BDR SONATA WEST
4561 MARTIN LUTHER KING WAY S

DESIGN REVIEW
REVISIONS

SDCI# 3017381
APRIL 12, 2016

ROOF DECK RECONFIGURATION

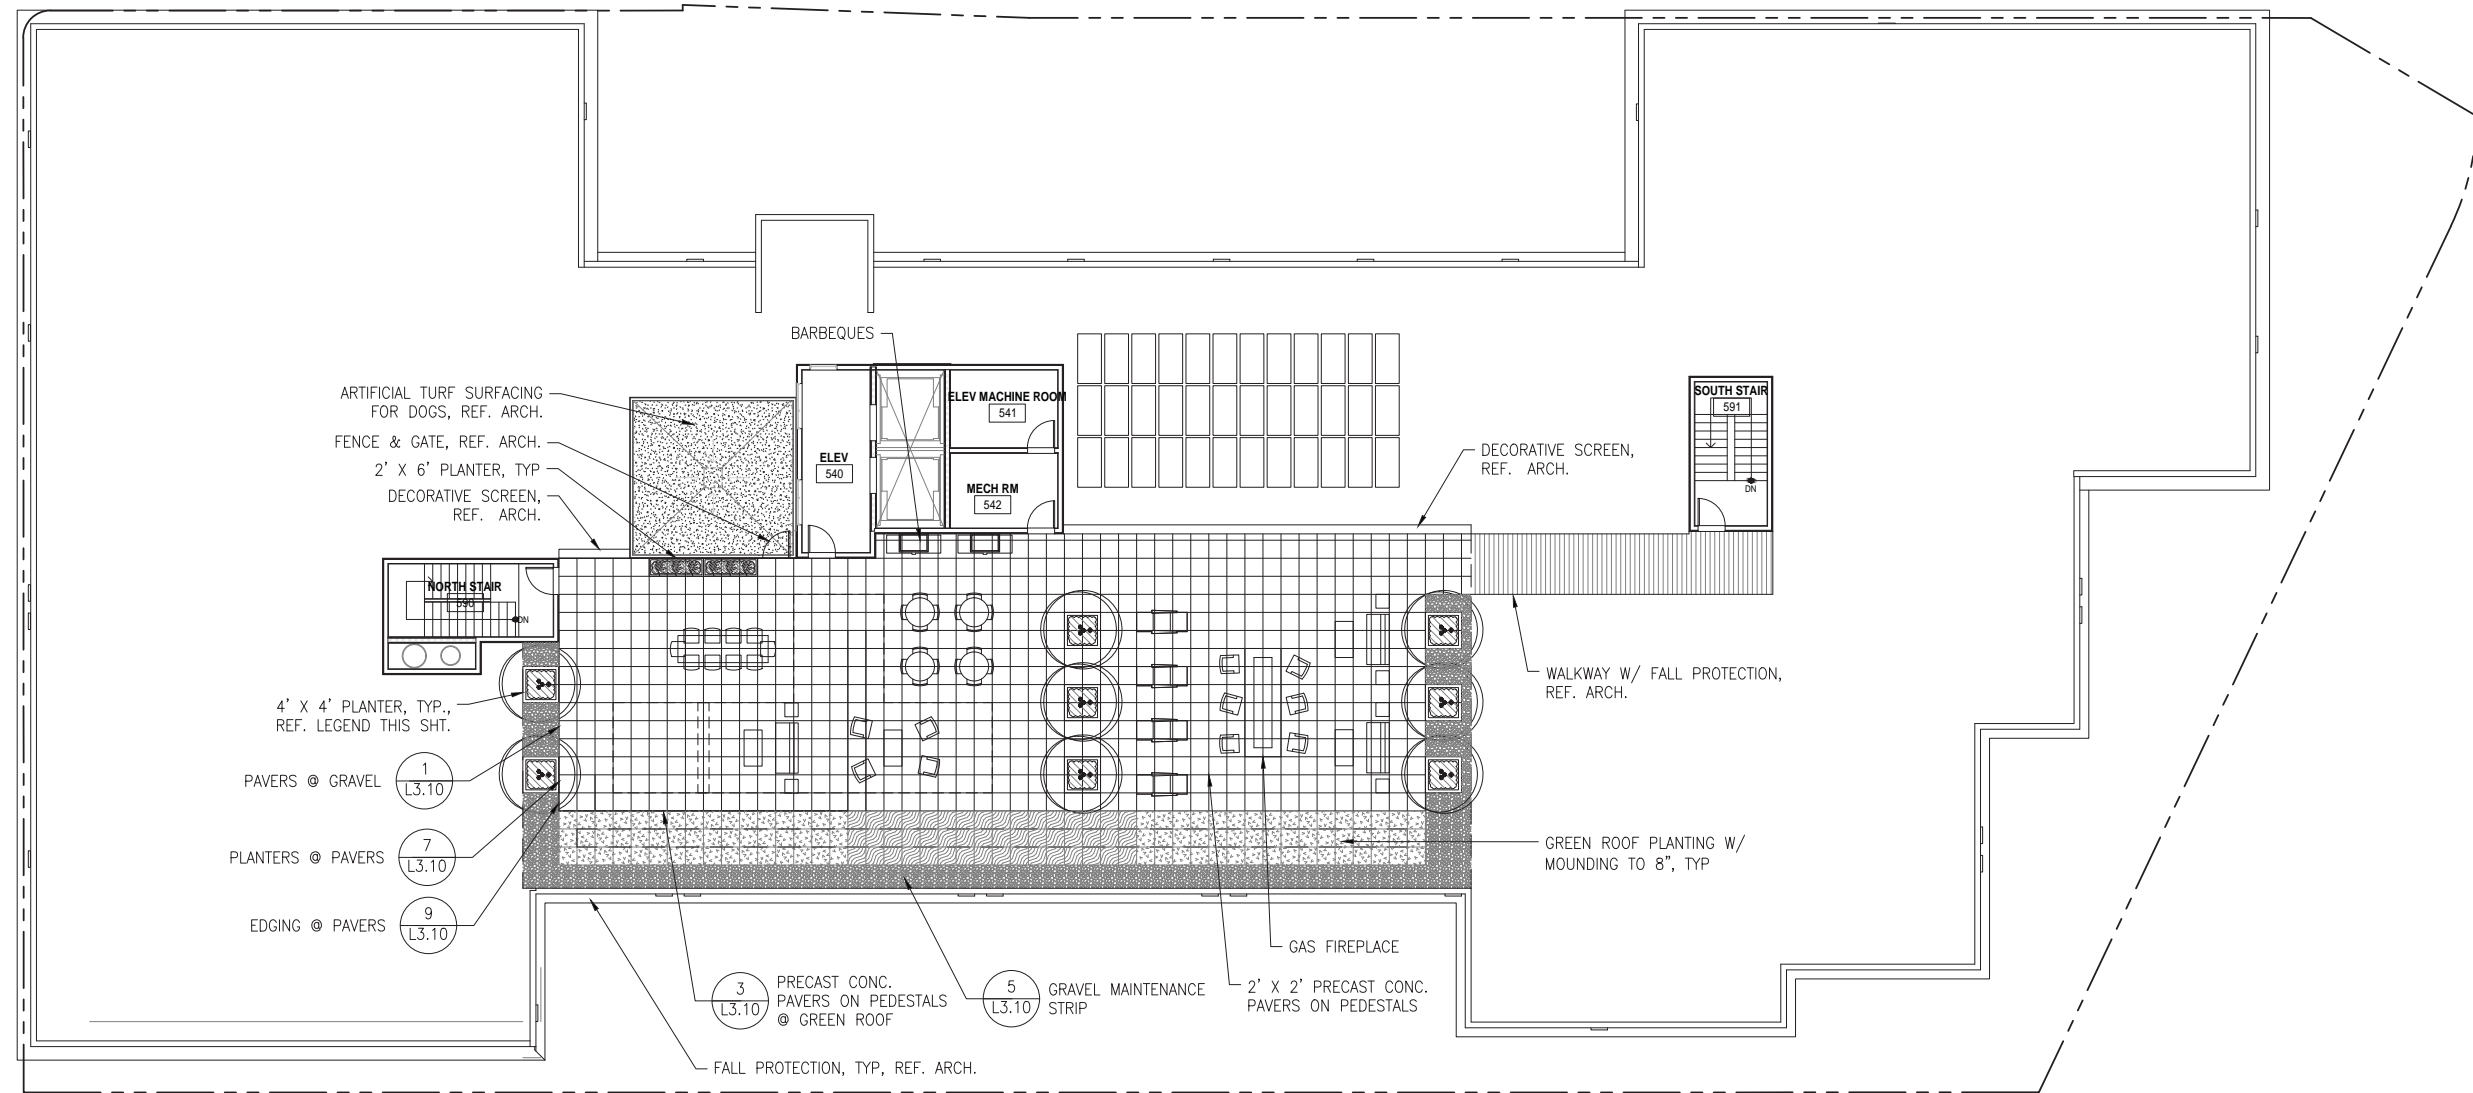
Since the first Design Review Recommendation meeting, the roof deck amenity location has shifted from the north east corner of the roof to the central west side. Through the design development of this project, and it's sister project across MLK Jr Way S, acoustical concerns were raised regarding the level of traffic noise coming

from the busy MLK, as well as the intersection with South Alaska Street and the Columbia City Light Rail station immediately to the south of the site. While the East project already had situated the roof deck on the side furthest from MLK, this roof deck had been placed on the side closest to MLK to take advantage of views south

east to Mount Rainier. While discussing the traffic noise concerns, the decision was made to shift the amenity area away from MLK to produce a quieter, more tranquil space.
